07 November 2018

RE: SIGMA PHARMACEUTICAL WAREHOUSE & DISTRIBUTION FACILITY MODIFICATION (SSD 7719 MOD 2) - RESPONSE TO SUBMISSIONS

Figure 1 – Comparison of the Landscape Plans for SSD7719

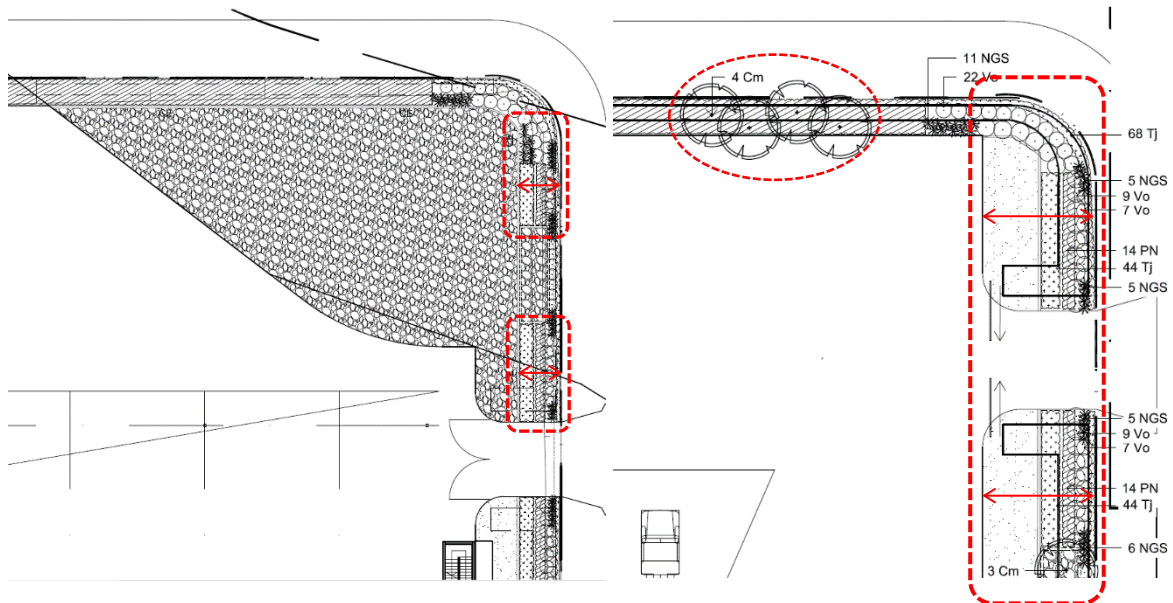
- *While the rezoning may be appropriate given the approved road configurations, the proposed extent of additional hard stand area now proposed is not considered to be appropriate at this intersection and an improved landscape setback between the property boundary and car parking areas should be required.*

- *The proposed plans provide for a 2.5m setback to Road 06 which is inadequate given the location of this site. The corner of the site (south east) requires an embellished landscape setback to frame the intersection of Estate Road 6 and Estate Road 1 which is planned to be embellished to the east and south. The extension of the hard stand out to the intersection area does not suitably respond to the contextual planned landscape character of this intersection, and an increased setback should be provided.*

The modification application seeks to convert the ballast (gravel) surface to hardstand area and amend the landscape setback along the eastern boundary. This is considered appropriate as it improves and increases the landscape setback to the north-eastern corner, and along the Estate Road 01 frontage. In addition, the proposed landscaping will align with the concept masterplan (SSD6917) boundary landscaping that proposes street tree planting, enabling consistency with the landscape strategy of the approved Oakdale South Estate. The clusters of street trees will provide visual screening of the facility and are planted every 7m along Estate Road 01 and every 9m along Estate Road 06.

Figure 1 demonstrates that SSD7719 MOD 2 increases the amount of turf and soft landscaping along the setback in the south-eastern corner of the site from 4m to 7.5m. This is considered an

improvement to the visual presentation to the corner and street frontages, in comparison to the approved SSD7719 landscape plan. The addition of turf and soft landscape to the corner creates consistency with the existing landscape setback along the Estate Road 01 frontage.

We note that the approved landscape plan for SSD7719 includes ballast (gravel) at the corner which is visually substantially the same as the hardstand area. The difference being that it is no longer a permeable surface. Views to the hardstand area will be appropriately mitigated by the increased (7.5m) landscape setback that is comprised of turf and layered plantings along the eastern boundary. For these reasons, the landscape treatment is considered to be not only appropriate but an enhancement to the south-eastern corner of the lot.
